Hi-Fi Products
Service Bulletin

Model: MDR-IF5K

No. 89R1

Subject: Improvement of Signal to Noise Response

On Headphones

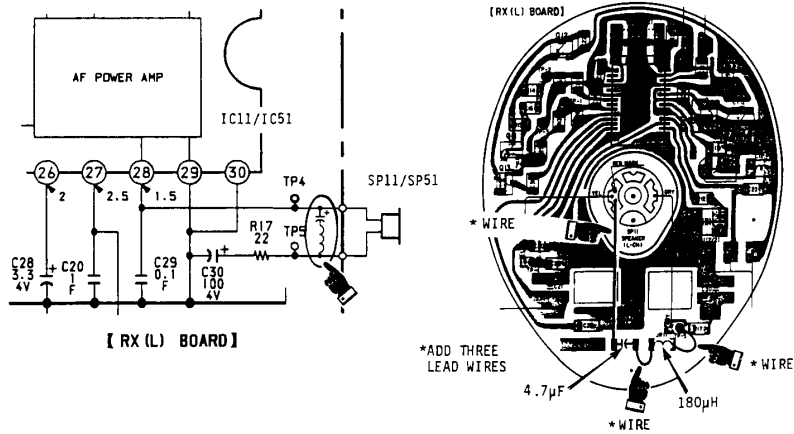
A high level of residual noise is present. This hissing is most noticeable during quiet passages.

Add a capacitor and a coil to both sides of SP11/SP51.

Description	Part Number
Chip, Tantalum Elect 4.7 μ F/4V	1-135-151-21
Chip, Inductor 180 μ H	1-410-657-21

On Transmitter

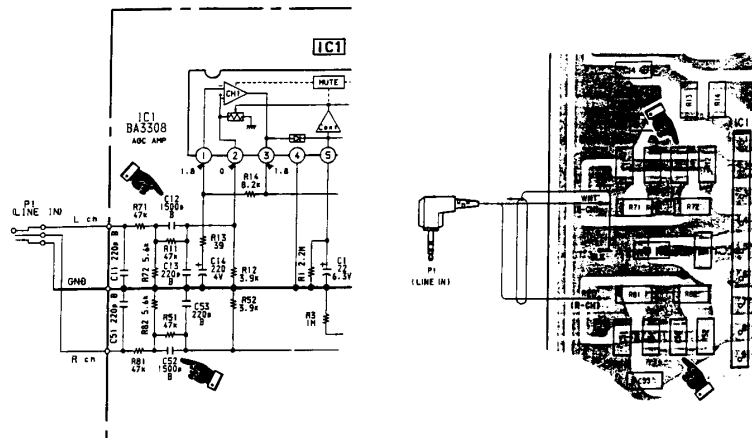
Change the value of C12/C52 from 1000pF to 1560pF by adding 560pF to C12/C52 in parallel.

Description	Part Number
Chip, Ceramic 560pF	1-163-199-00
